MIL-PRF-83536/2
AMENDMENT 4
10 July 1999
SUPERSEDING
AMENDMENT 3
21 August 1998

PERFORMANCE SPECIFICATION SHEET

RELAYS, ELECTROMAGNETIC, ESTABLISHED RELIABILITY, DPDT, LOW LEVEL TO 5 AMPERES, PERMANENT MAGNET DRIVE, HERMETICALLY SEALED, ALL WELDED, TRANSIENT SUPPRESSED DC COILS

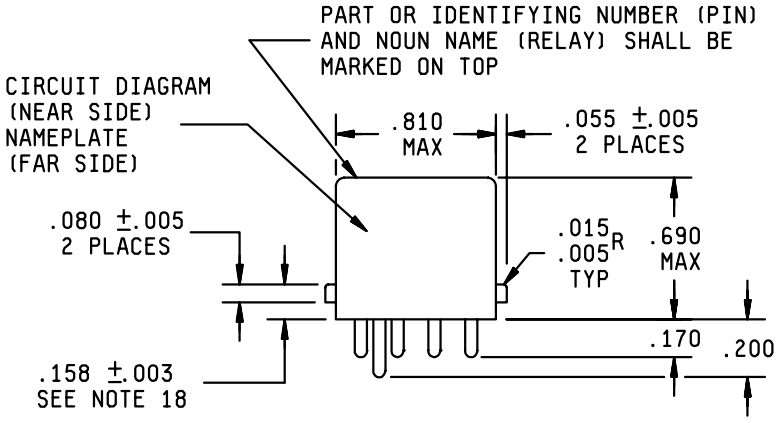
FIGURE 1, track mount A, side view, delete and substitute:

CIRCUIT DIAGRAM (NO MOUNT, RVFM, HFH AND TRACK MOUNT A)
(OPTIONAL INTERNAL
DIODE CONFIGURATION)

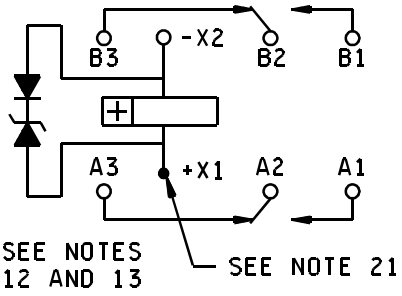
FIGURE 1, add the following circuit diagram between the existing diagrams:
